2.0 SITE CHARACTERISTICS

This chapter of the Fermi 3 Combined Operating License (COL) Final Safety Analysis Report (FSAR) addresses the geological, seismological, hydrological, and meteorological characteristics of the site and vicinity, in conjunction with present and projected population distribution and land use, and site activities and controls.

Section 2.0 of the Fermi 3 COL FSAR, Revision 7, incorporates by reference Section 2.0 of the ESBWR DCD, Revision 10. In addition, the applicant provides the following:

Figure 2.4.3-1. Hourly Distribution of the Probable Maximum Precipitation for the Swan Creek Watershed

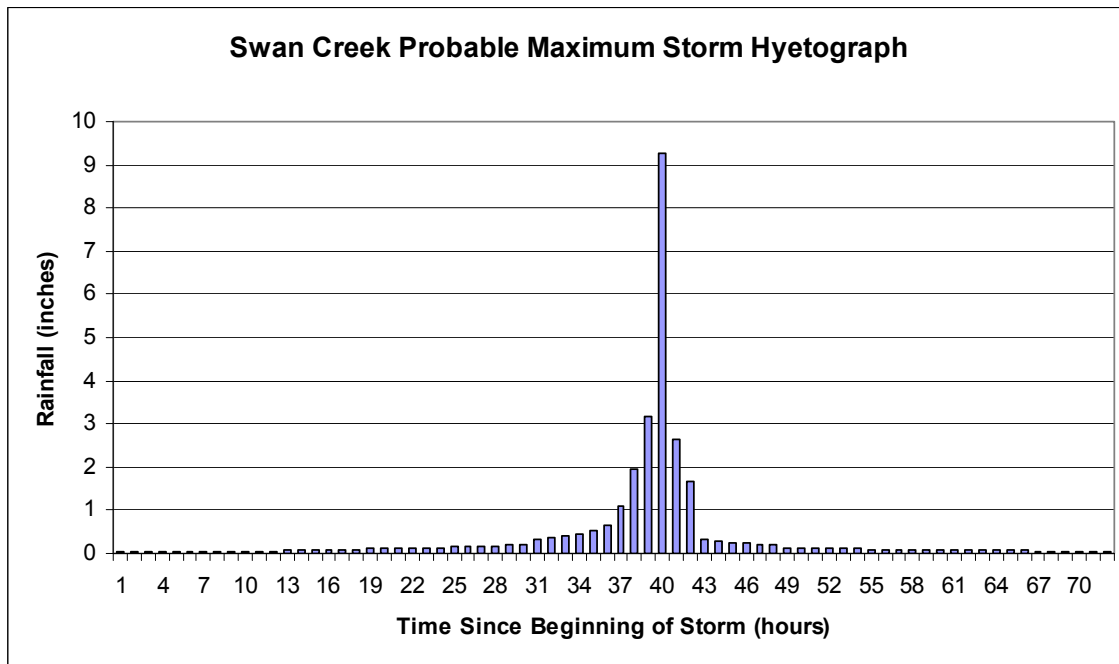
The applicant's input and output values for the HMR-52 program were very similar to the staff's. Both the staff and the applicant used a value of 0.302 for the ratio of the 1 to 6 hour storm. The staff found a maximum storm orientation of 309 degrees and the applicant found a maximum storm orientation of 311 degrees. The depth-area-duration curves used by the applicant were slightly larger overall than those used by the staff, and thus the applicant's analysis was more conservative. Therefore, the applicant's input values were found to be acceptable. The applicant calculated a PMP of 28.9 from the HMR-52 software, the same value determined by the staff's calculation.

Figure 2.4.3-2. Hourly Distribution of the Probable Maximum Storm with Snowmelt for the Swan Creek Watershed

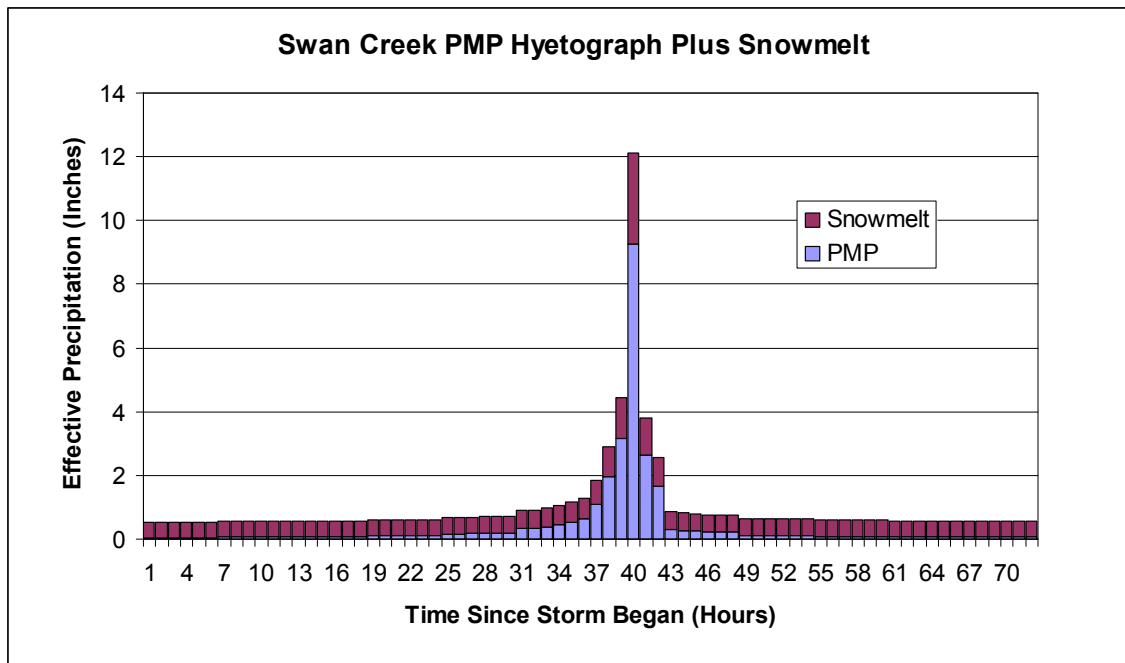
The applicant calculated snowmelt for each time step using Equation 5-19 from the USACE manual *Runoff from Snowmelt* (USACE, 1998). A full discussion of the verification of the snowmelt calculations is presented in SER Subsection 2.4.2.4 above. The staff verified the results of the snowmelt calculations and independently calculated the same cumulative rain and snowmelt total of 70.3 inches over 72-hours.

The staff-calculated PMP with snowmelt for the Swan Creek Watershed shown in Figure 2.4.3-1 above can be directly compared to Figure 2.4-XX-3 submitted by the applicant with the response to RAI 2.4.2-1, dated September 30, 2009 (ADAMS Accession No. ML092790561). The staff finds the applicant’s calculation of PMP with snowmelt to be acceptable, because the applicant’s PMP is the same as the value calculated by the staff.

Figure 2.4.3-3. Probable Maximum Flood Runoff using HEC-HMS 3.1.0 Rainfall-runoff Model

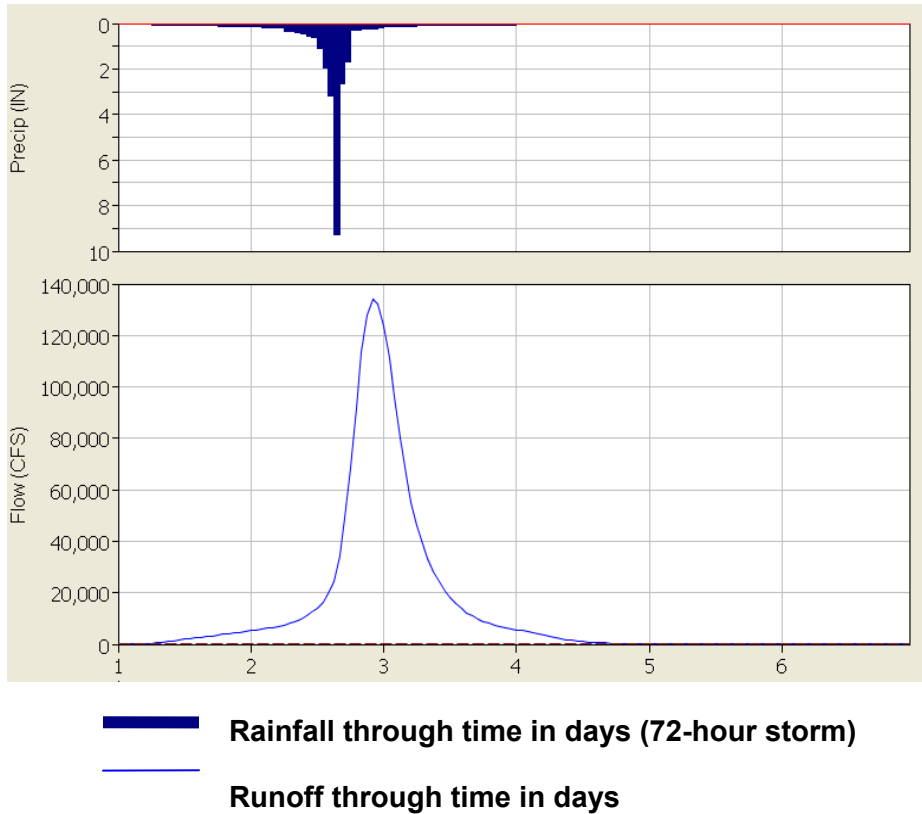
The NRC staff reviewed the information submitted by the applicant concerning the flow resulting from the PMF. The NRC staff independently calculated the PMF for Swan Creek using the SCS unit hydrograph method in HEC-HMS 3.1.0. The staff obtained a value of 134,000 cfs, which is approximately 18 percent higher than the value presented by the applicant. Though these (134,000 and 168,000 cfs) values (and the snowmelt values discussed below) are of an unreasonably large magnitude for Swan Creek, they result in highly conservative estimates using the applied methodology and are therefore useful for evaluation purposes. The staff used the smallest and most conservative time of concentration value calculated by the three methods presented above, 413 minutes. The staff also assumed a constant baseflow equivalent to the mean monthly flow for the month of April presented in Table 2-215 of the FSAR of 120 cfs.

In Figure 2.4.3-3, the staff developed flood hydrographs based on the parameters discussed above. By developing an independent hydrograph, Figure 2.4.3-3 can be directly compared with Figure 2.4-219 of the FSAR to examine the PMF runoff calculated by the staff versus the PMF runoff calculated by the applicant.

Figure 2.4.3-4. Probable Maximum Flood with Snowmelt Runoff using HEC-HMS 3.1.0 Rainfall-Runoff Model

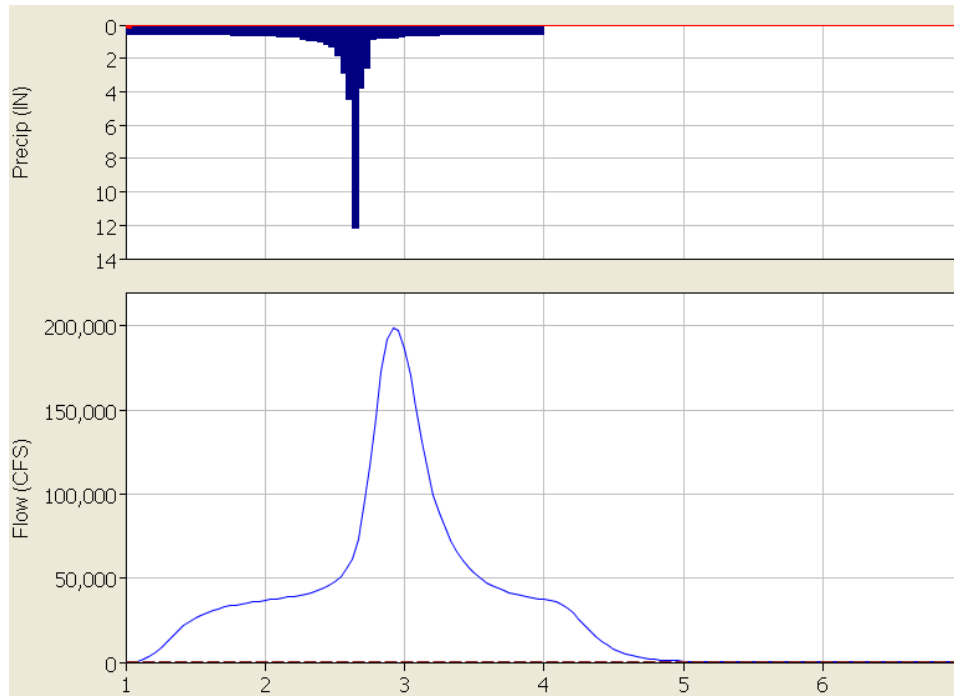
The NRC staff independently calculated the PMF with snowmelt for Swan Creek and obtained a value of 199,000 cfs, which is approximately 18 percent higher than the value presented in the response to RAI 2.4.2-1, dated September 30, 2009 (ADAMS Accession No. ML092790561).

In Figure 2.4.3-4, the staff independently developed a flood hydrograph that include snowmelt. The staff hydrograph in Figure 2.4.3-4 can be directly compared with Figure 2.4-2-XX-4 of the response to RAI 2.4.2-1, dated September 30, 2009 (ADAMS Accession No. ML092790561) to examine the runoff from the PMF plus snowmelt calculated by the staff versus the PMF plus snowmelt runoff calculated by the applicant.

Figure 2.4.5-1. Wave Height and Bathymetry of the Western Lake Erie Derived by STWAVE

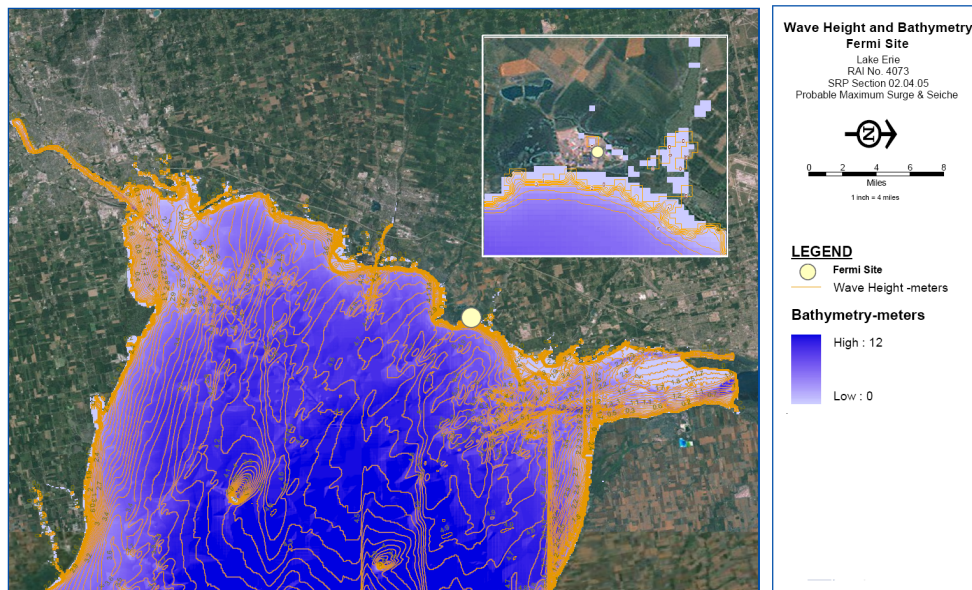
In the responses to RAI 2.4.5-3 and RAI 2.4.5-7, the staff verified the results derived by the applicant by modeling the entire area of Lake Erie using the model grid of 100 m using STWAVE. The resulting distribution of wave heights is shown in Figure 2.4.5-1.

Figure 2.4.5-2. STWAVE Data Points Near Fermi 3

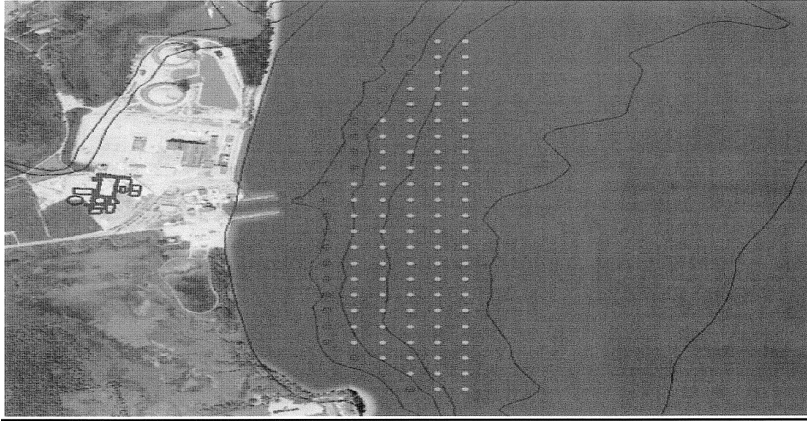
The STWAVE data points near the Fermi 3 are shown in Figure 2.4.5-2. The wave periods at all these points are 11.1 seconds. The wave height at the point near Fermi 3 is 3.7 m. The

wave parameters selected by the applicant using STWAVE are conservative based on the staff's independent verification using additional data received in RAI responses. These parameters, including wave period and distribution of wave height, were used for further calculation of wave action across the shore.

Figure 2.5.1-5 Photographs of Strata in the Denniston Quarry, Monroe, Michigan.

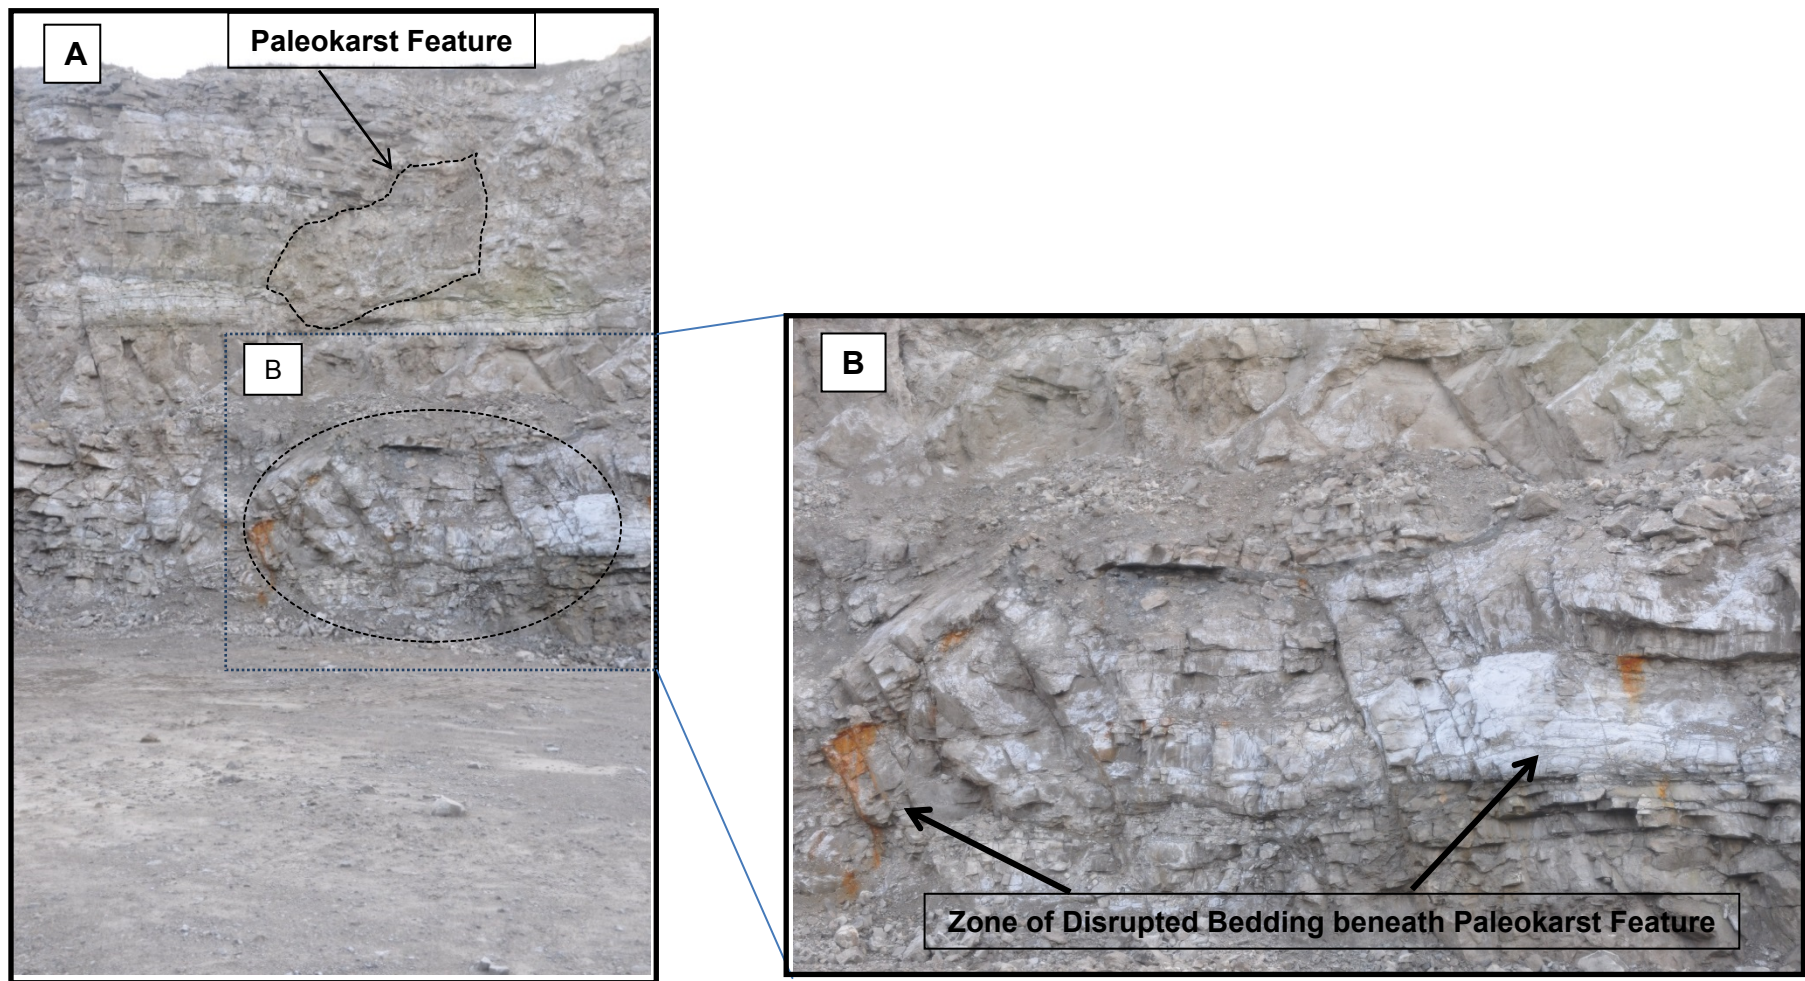
During the NRC staff's visit to the Denniston Quarry in Monroe County, Michigan, as part of a November 2009 Fermi 3 COL site audit, the staff noted at least three zones of disrupted bedding exposed in the quarry walls. These disrupted zones suggest possible faulting of the Bass Islands Group. In one location, disrupted bedding exists beneath an interpreted paleokarst feature (located near the top of the geologic section) and suggests that the paleokarst development may be associated with faulting at depth. Figure 2.5.1-5 in this SER shows this paleokarst feature above a zone of disrupted bedding in the Bass Islands Group. In a second quarry location, a zone of disrupted bedding exists with mostly undisturbed bedding on either side. This second zone appears to be at least seven to ten meters wide; contains disrupted bedding from the top to the bottom of the exposed wall; and is flanked by relatively undisturbed bedding on both sides. The third zone of possible disturbed bedding was visible in a distant wall and could be related to vertical offsets within the Bass Islands Group.

Figure 2.5.2 -8 Earthquakes with Magnitudes Equal to or Greater than 3.0 in the CEUS between 2009 and 2012

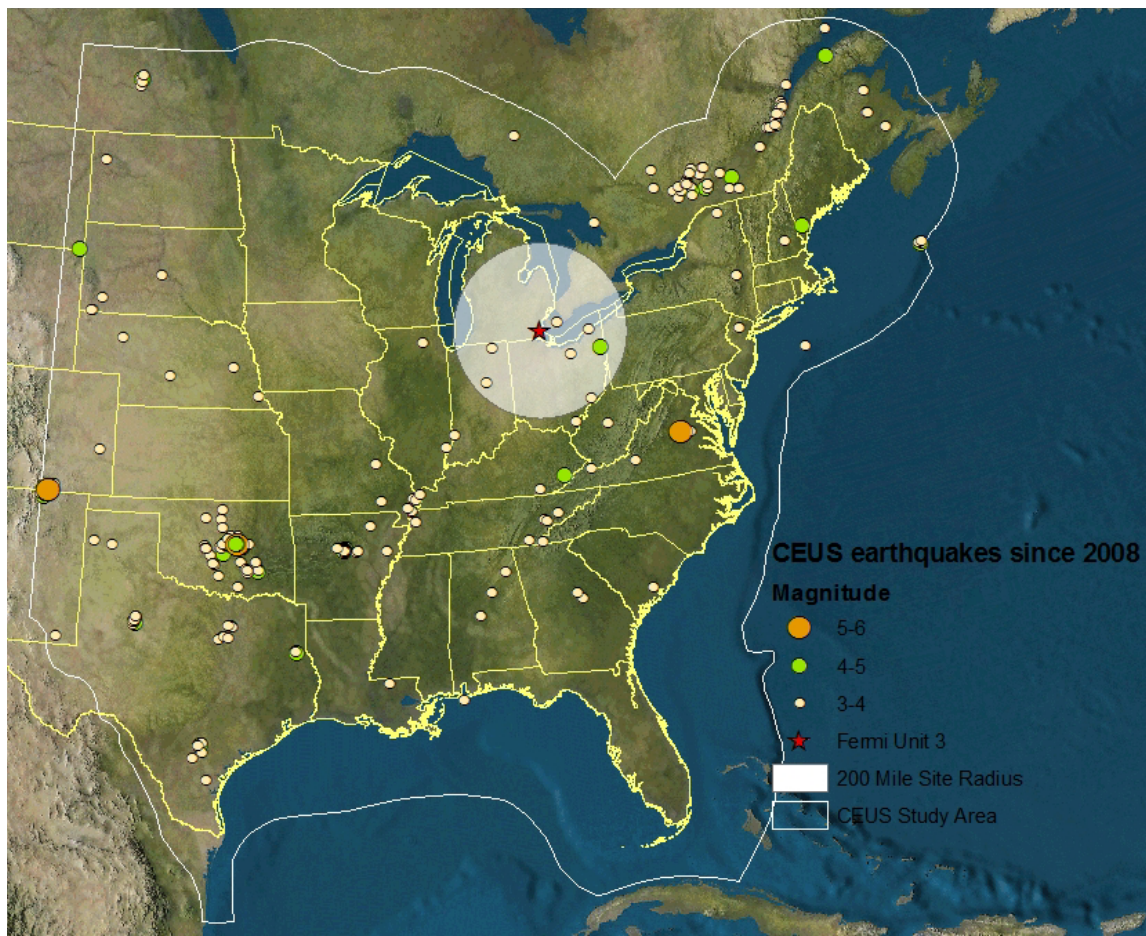
The staff developed a supplementary earthquake catalog covering the CEUS region from 2009 through 2012, in order to evaluate the completeness of the applicant's updated catalog and subsequent conclusions. The staff used the USGS ANSS, which is in Figure 2.5.2-8 in this SER. The staff compared this recent seismicity with the applicant's updated catalog in FSAR Figures 2.5.2-202 and 2.5.2-203. The staff concluded that the recent seismicity does not show any significant deviations from the applicant's updated seismicity catalog. Therefore, the staff concludes that the Fermi 3 earthquake catalog adequately characterizes the regional and local seismicity through 2012.

Figure 2.5.2-9 Plot Comparing the Staff's and the Applicant's 1-Hz Total Mean Hazard Curves for the Distributed Seismicity Source Zones

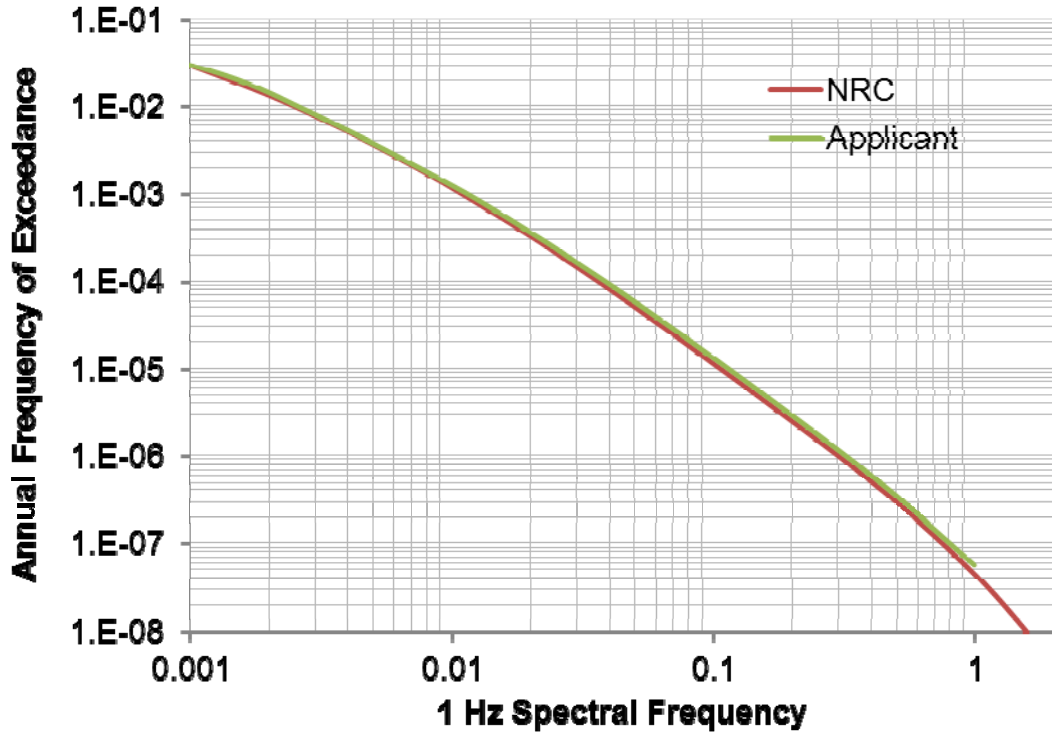
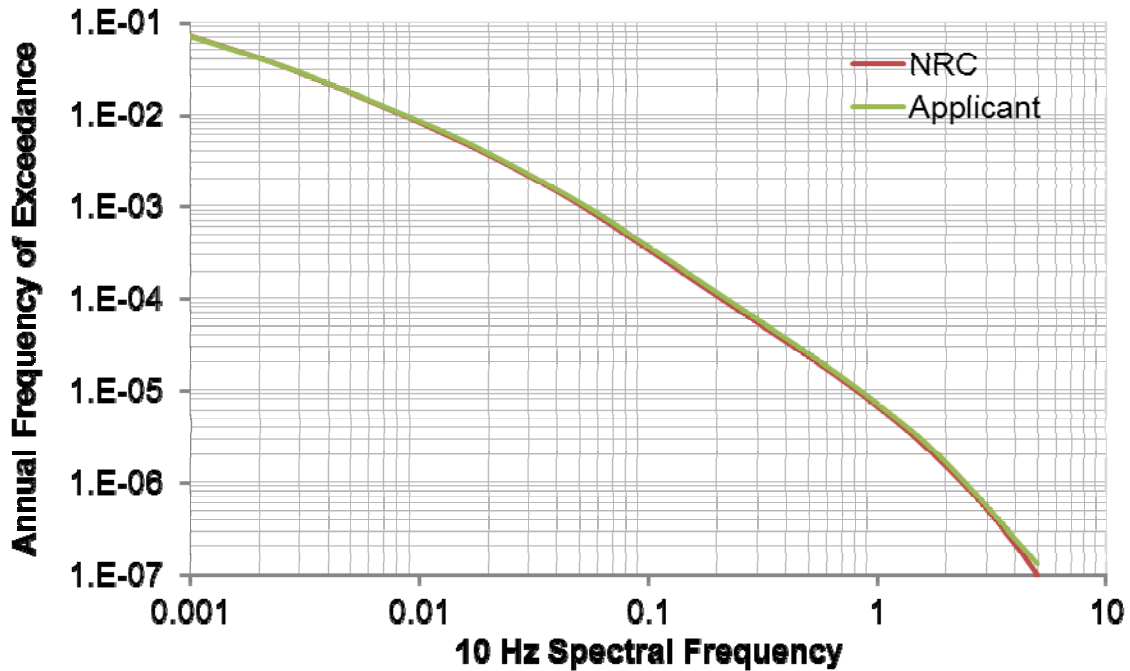
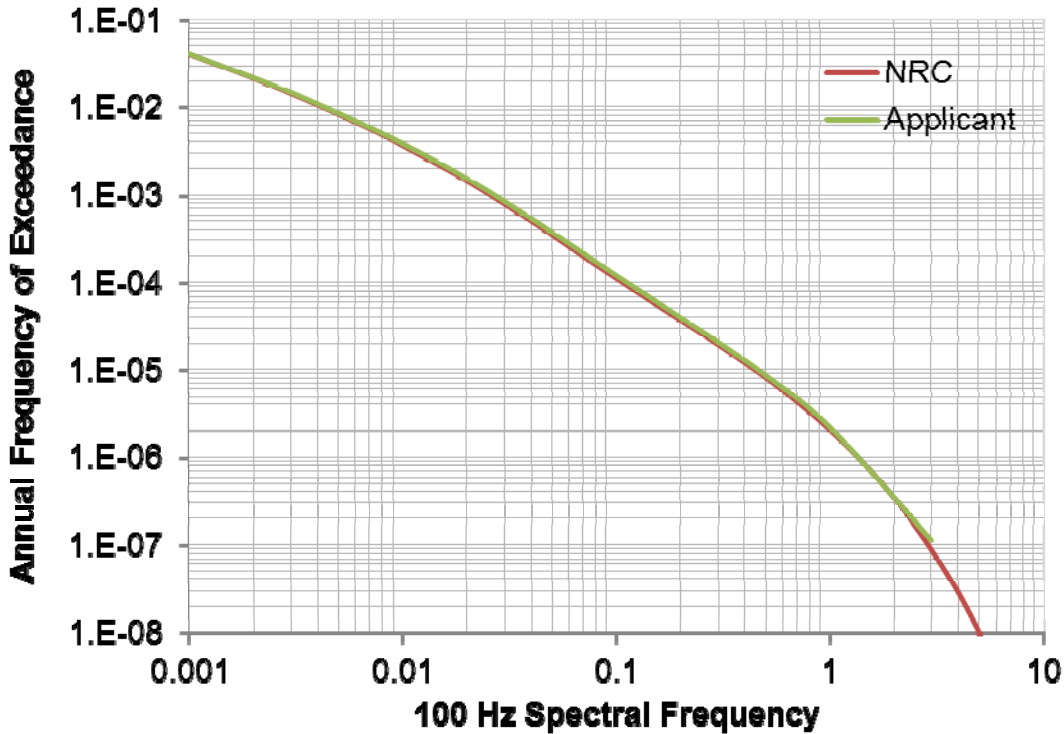
results are almost identical. This finding is illustrated in Figures 2.5.2-9 through Figure 2.5.2-11 in this SER showing the PSHA hard rock hazard curve results for 1, 10, and 100 Hz, respectively, for the distributed seismicity sources.
